Our Ref: P256595
13 May 2025

Application reference 2025/1489/P

Extension and refurbishment of the existing church building including an ancillary cafe and new level access from Finchley Road. Holy Trinity Church Finchley Road London NW3 5HT

Current roof directly adjoining Alban House

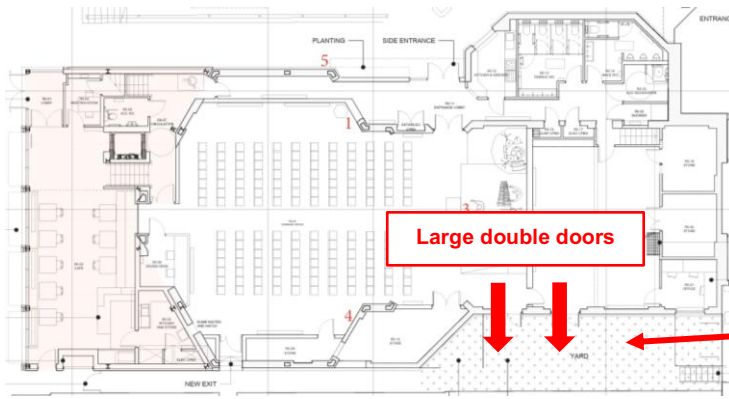
Of particular concern to Alban House is the potential noise breakout from the new rooflights above the main stage and worship space. As shown on the following photograph the existing roof is solid without any window openings.

However six new rooflights are proposed in the main roof and two further within the smaller section directly adjoining Alban House.

The plans do not provide sufficient detail to determine whether the rooflights would be openable or simply fixed panes. If openable clearly this has the real potential to result in noise impacts for Alban House. Even if the rooflights are to be fixed no detail has been provided in terms of the acoustic properties of the glazing. An assessment is required in this regard.

Ground floor plan

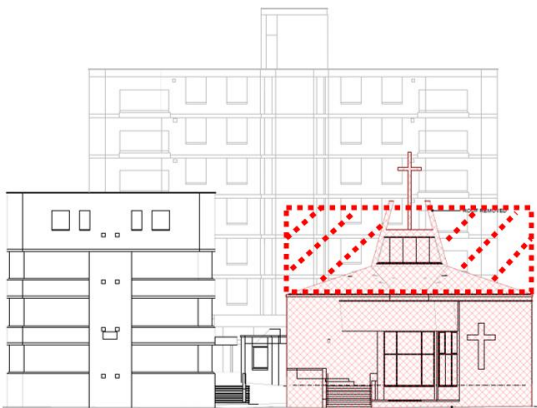
At present this space is largely unused but the proposed plans show two sets of double doors opening out onto this space. The area is within very close proximity of the front windows and balconies of the Alban House properties and the rear windows of The Quarters. If the doors are left open during services or performances this would result in significant noise concerns.

Similarly the use of this space as a breakout area where people may gather has the potential to cause noise and disturbance for the residents of Alban House and The Quarters. The application should clarify the applicants intent for this space so that the impacts can be considered as part of the application.

Finally the plans show a bell of reasonable scale located to the north side of the building. Its use is unclear. However by its nature subject to its proposed use / frequency of use it is likely to cause disturbance to Alban House residents. This matter is not addressed in the acoustic report or elsewhere in the application package. This matter should be clarified by the Applicant.

Existing elevation with additional massing added

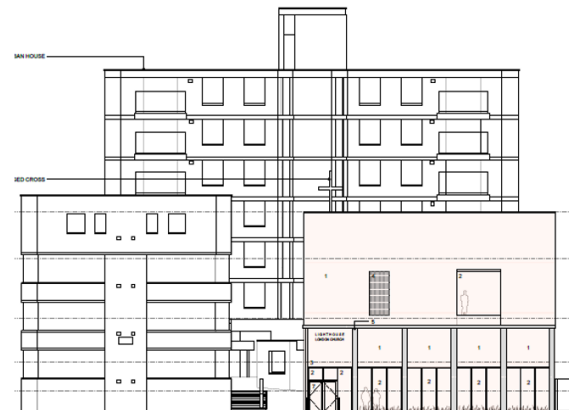
As shown below the proposed works will increase the apparent bulk and massing of the building in front of Alban House.

Proposed elevation view from Alban House

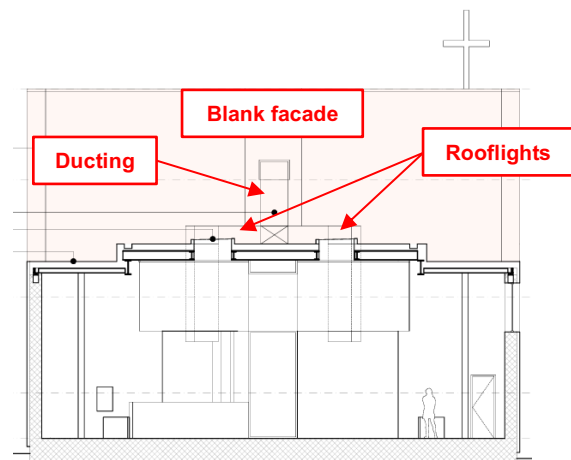
As shown opposite, the rear (east) elevation facing Alban House is proposed to be a blank rendered façade with plant ducting running down from the plant area onto the replacement flat roof.

In summary where residents currently look out past and around the conical shaped rood this outlook will be removed (particularly for those at 2nd and 3rd floor levels) and replaced with a full blank wall removing this sense of space.

These changes will clearly harm outlook, reduce the sense of openness and particularly at night draw the eye with large light rooflights being visible just in front of the flats at Alban House.
